# CITY OF ALBUQUERQUE

May 5, 2017

**RE: Paseo Marketplace  
Conceptual Grading Plan  
Revision Stamp Date: 5/3/17  
Hydrology File: D18D056**

Based upon the information provided in your re-submittal received 5/4/2017, the Conceptual Grading Plan **is not** approved for Building Permit, Site Plan for Subdivision, Site Plan for Building Permit, Grading Permit, and SO-19. The following comments need to be addressed for approval of the above referenced project:

**C-1**

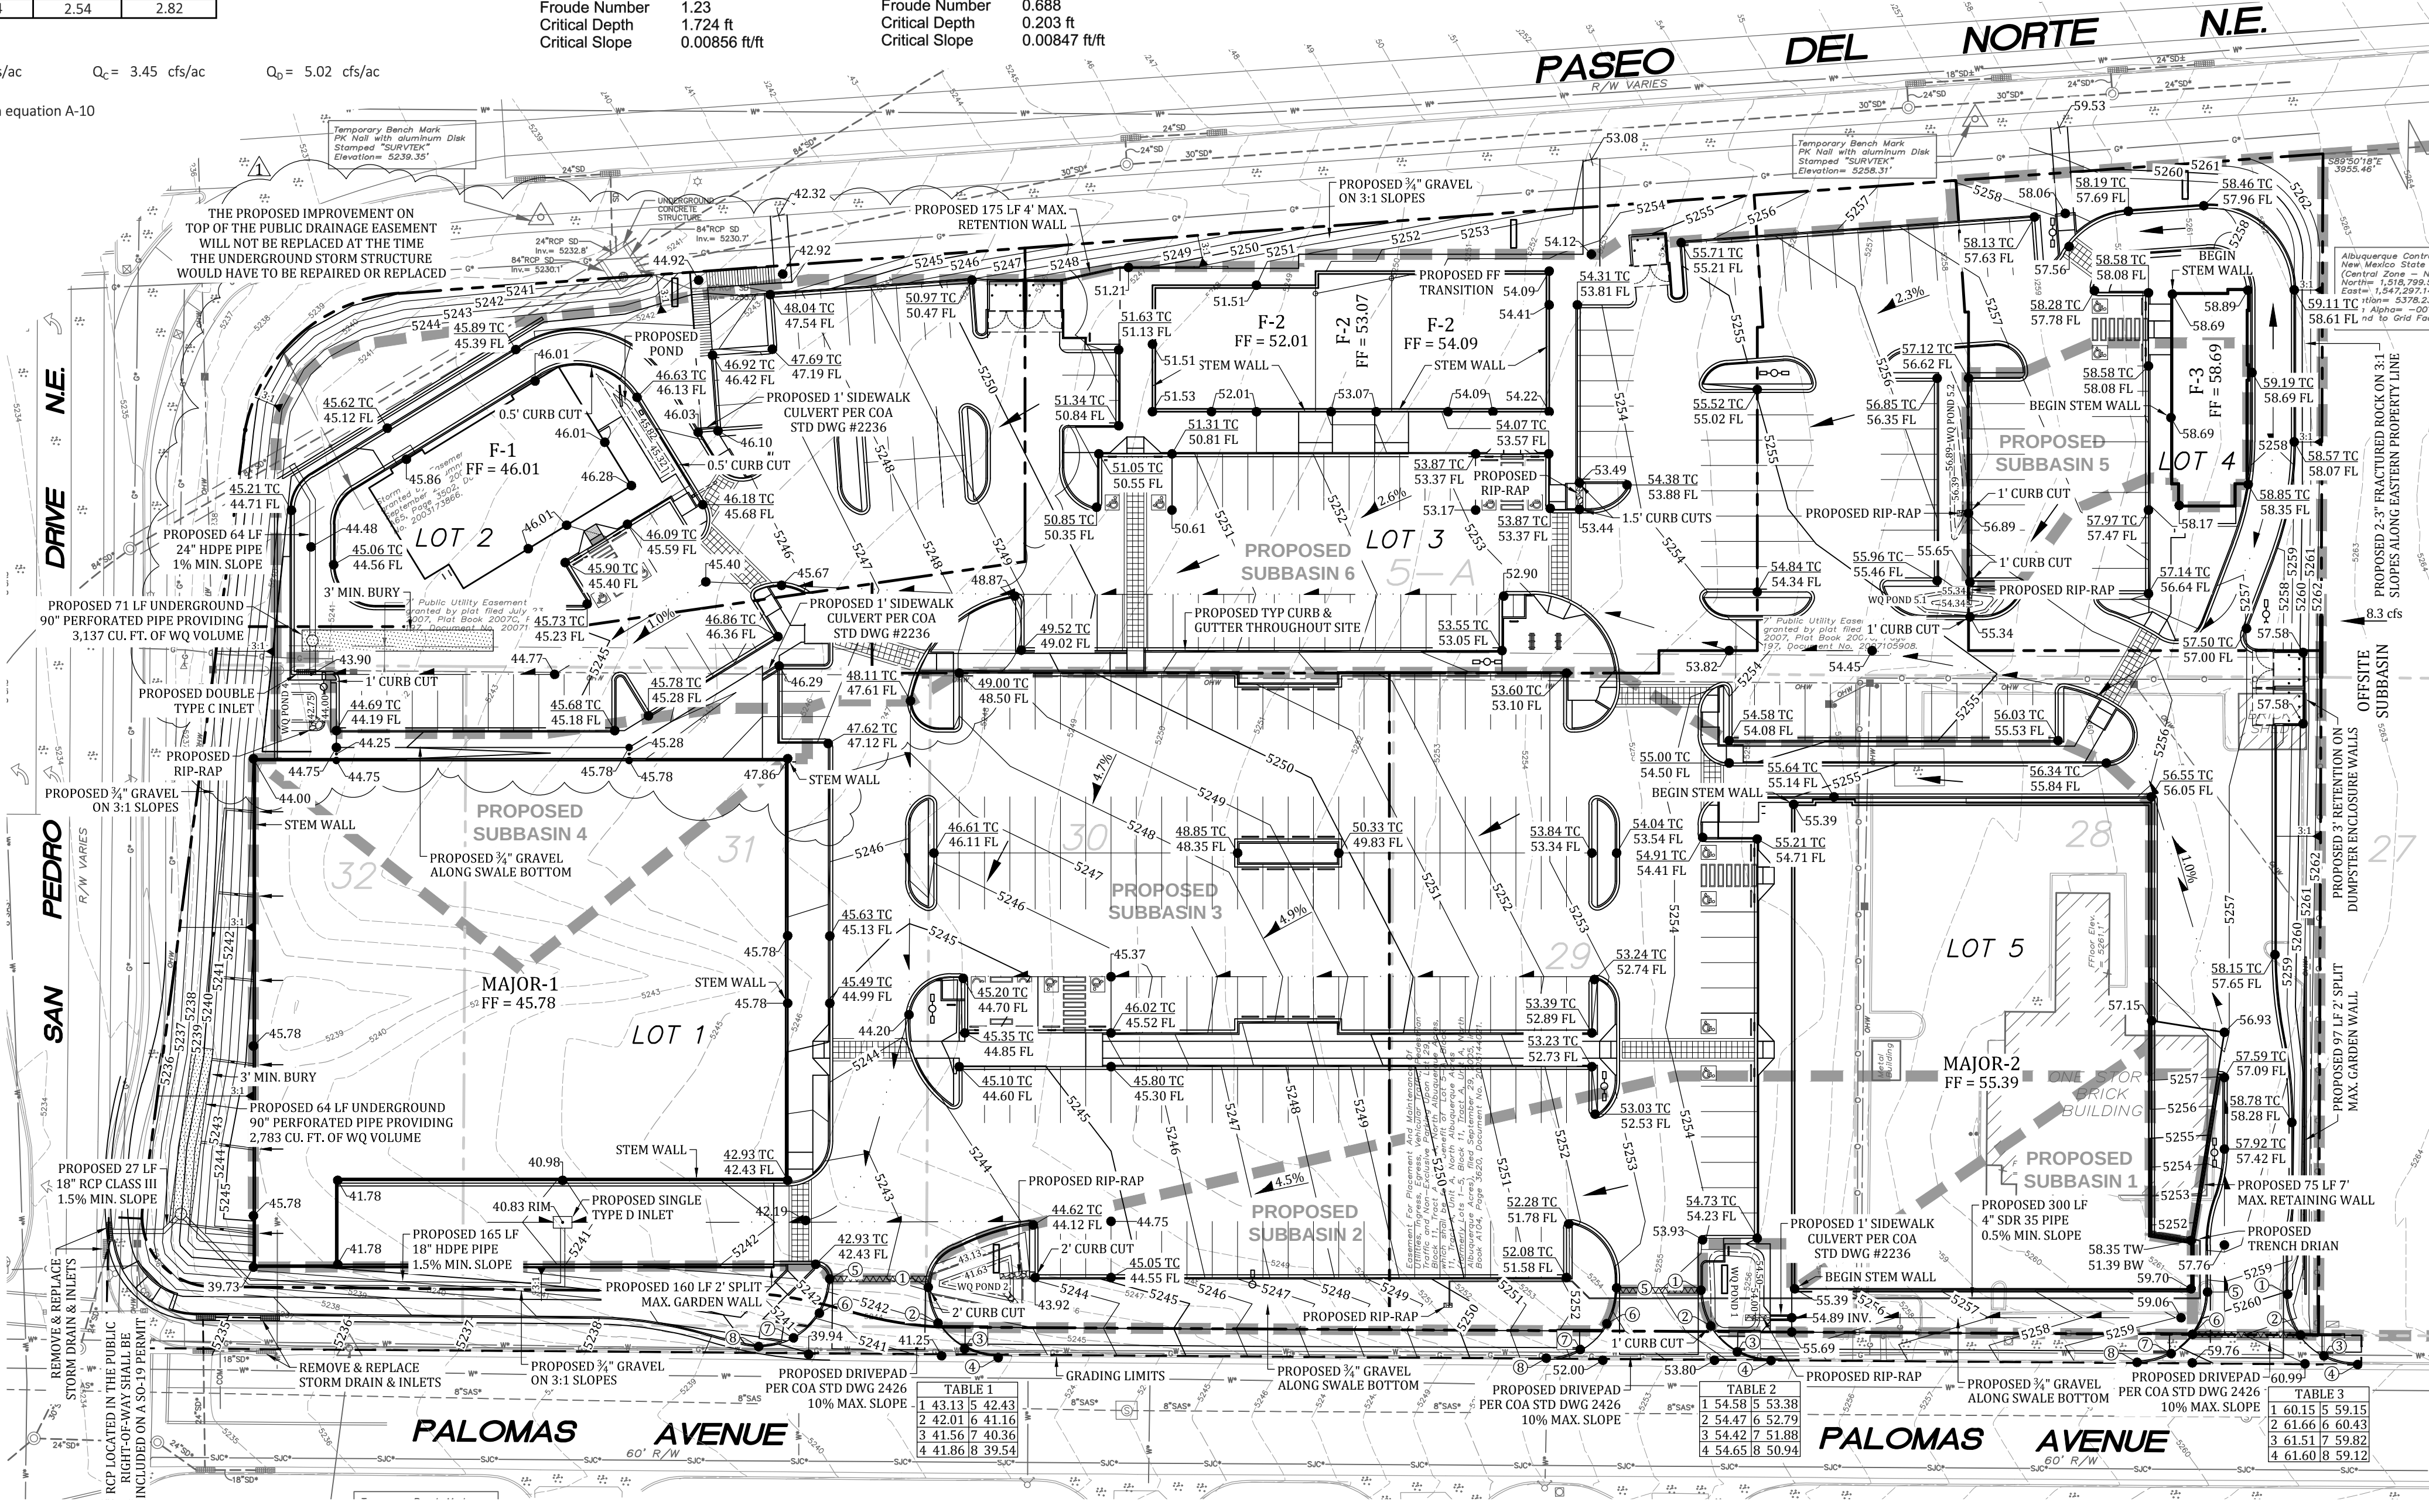
1. Under the Proposed Conditions – Subbasin 6, it states that the runoff will eventually reach the double Type A inlet. Since the inlets are not double Type A but double Type C as shown on the revised plans, please update.

2. Under the Proposed Conditions – Subbasin 6, the WQ volume required should be 3,132 CF as noted in the first flush volume calculations. Please update.

3. Included on the plans is The Oriffice & Weir Calculation for a double Type A inlet. Since the inlets are not double Type A but double Type C as shown on the revised plans, please update the Oriffice & Weir Calculations for a double Type C inlet.

4. Next to Building F-1, there is a proposed pond. Please provide the volume of this pond. Is this pond needed? I do not see this pond in the Proposed Conditions – Subbasin 6 paragraph. Please update if pond is needed.

5. It appears that only the note for the newly proposed Type C inlet is shown on the plan. Please show the newly proposed double Type C inlet. Also please label the rim and flowline elevations for the double Type C inlet.

6. The shown boundary of the Proposed Subbasin 4 was not updated with the revisions to Building F-1 and surrounding pavement. Please update boundary which will also effect Subasin 3 and 6 areas and supporting calculations. The calculations for all three Subbasins should be revised.

7. The proposed swale in Subbasin 4 does not match the revised proposed contours. Please update the swale or contours to reflect the proposed swale. Please also show the drainage arrows.

8. The one inch curb cut near WQ pond 4 did not get relocated in the revisions. The newly proposed Subbasin 6 drainage flow line to the double Type C inlets is very close to the one inch curb cut and drainage from Subbasin 6 will outfall through this to WQ pond 4. Please either relocate the one inch curb cut if it is still needed or remove it if it is no longer needed.

9. It appears that WQ pond 4 size and shape have changed with the revisions, however the water quality pond rating curve for the pond did not change. Please revise the calculations so that the required volume for Subbasin 4 is being handled in the revised WQ pond 4. If needed, than adjust WQ pond 4 so that it will hold the required volume.
